**1.3 36 BEDDOE AVENUE, CLAYTON
CONSTRUCTION OF A FOUR STOREY BUILDING WITH BASEMENT CARPARK FOR
STUDENT ACCOMMODATION AND A CONVENIENCE SHOP
(TPA/52096)**

The proposal is considered inconsistent with the relevant provisions of the Monash Planning Scheme and it is recommended that the application be refused.

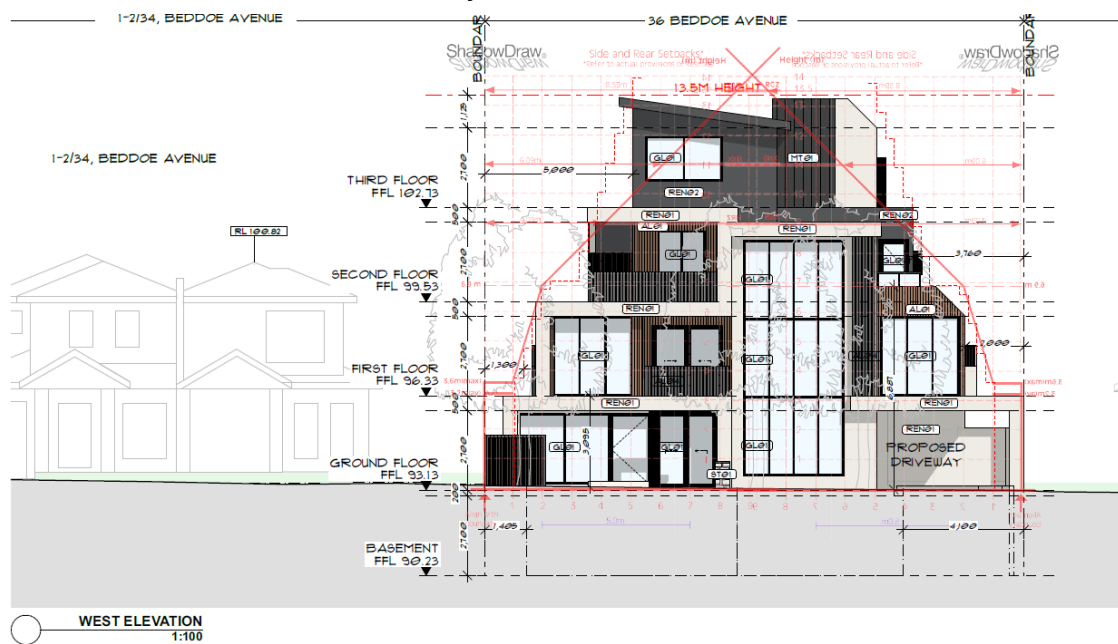
- The design response does not demonstrate a high quality design and finish. The façade treatment lacks adequate visual interest for its residential use and is dominated by the three storey stair wall with minimal variation in setback. The building proposes a basic palette of materials and finishes, with the majority of the building finished in similar shading of greys and whites.

- Along the northern and southern elevations the full length of the building is provided with minimal variations in setback which results in a lengthy built form of approximately 32 metres without any visual break. The upper levels are recessed however without an appealing architectural response it results in an unattractive boxy ‘wedding cake’ built form outcome.

- The proposal will significantly overshadow the south adjoining single storey dwellings which have small secluded private open spaces to the north of the dwellings (south of the subject land). The proposal has not been designed in response to this sensitive interface and amenity of these existing dwellings will be substantially compromised. Whilst higher densities and built form are encouraged by the zone, this must be balanced with consideration of the impact of any development on adjacent properties that may remain in its current form irrespective of the zone allowances. External amenity impact should be minimised through the design of the proposal with suitable breaks and setbacks which has not been achieved in this proposal.

Shadow at 9am and 10am when the impact of overshadowing to the south adjoining properties is the least throughout the day

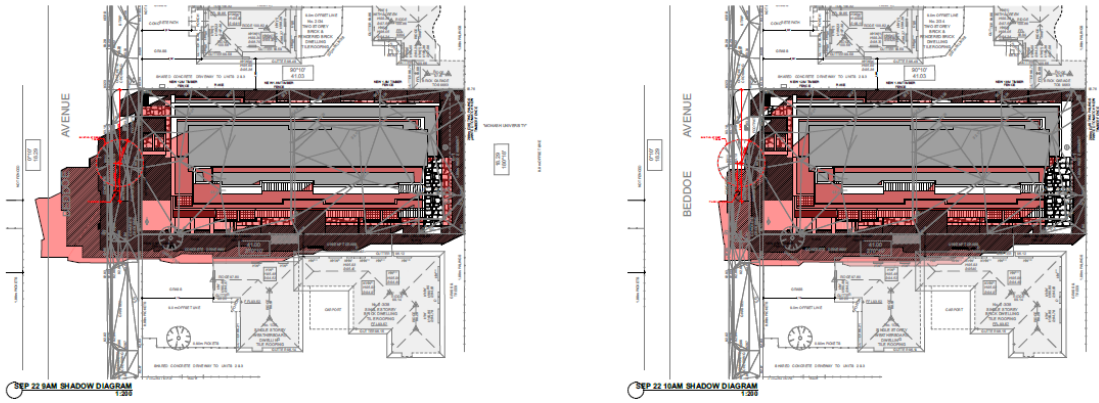
- The proposal does not comply with Standard B21 *Overshadowing Open Space Objective* of Clause 55.05-4. Fundamentally, the secluded private open space of the adjoining properties to the south are unreasonably impacted. Whilst some shadow is cast upon those areas by the existing boundary fence, the proposed development at this scale with the reduced setbacks proposed will further compromise the usability of these areas and all but eliminate any remaining sunlight that makes its way into these secluded private open space areas. A further reduction in sunlight upon these areas cannot be seen as acceptable even where the zone envisages greater than height and densities. The shadow diagrams submitted confirm that additional shadow will fall onto these secluded private space from 9am to 3pm and the development fails to satisfy the requirements of Standard B21.

Shadow at 11am and 12noon

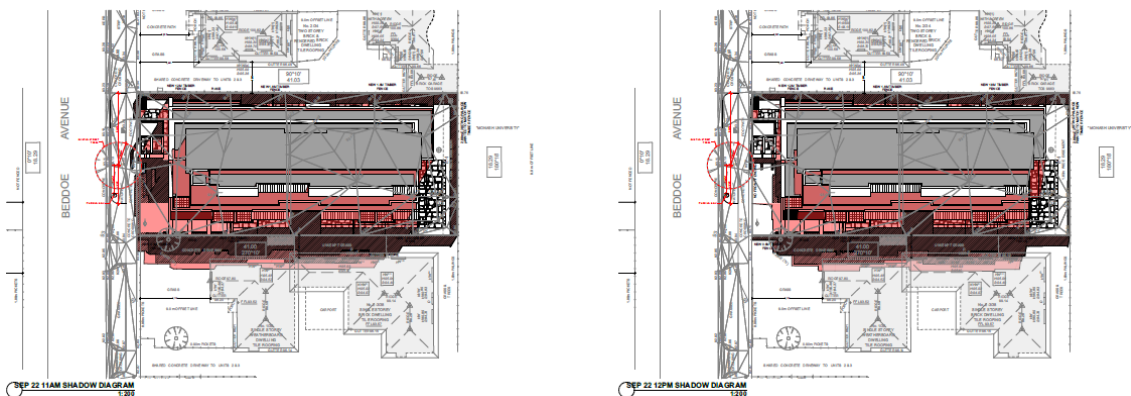
- In addition to the secluded private open space, the existing solar panels on the adjoining properties are likely to be overshadowed by the proposed development from 10am onwards. The impact of overshadowing to the solar panels will be worst between 11am to 3pm.
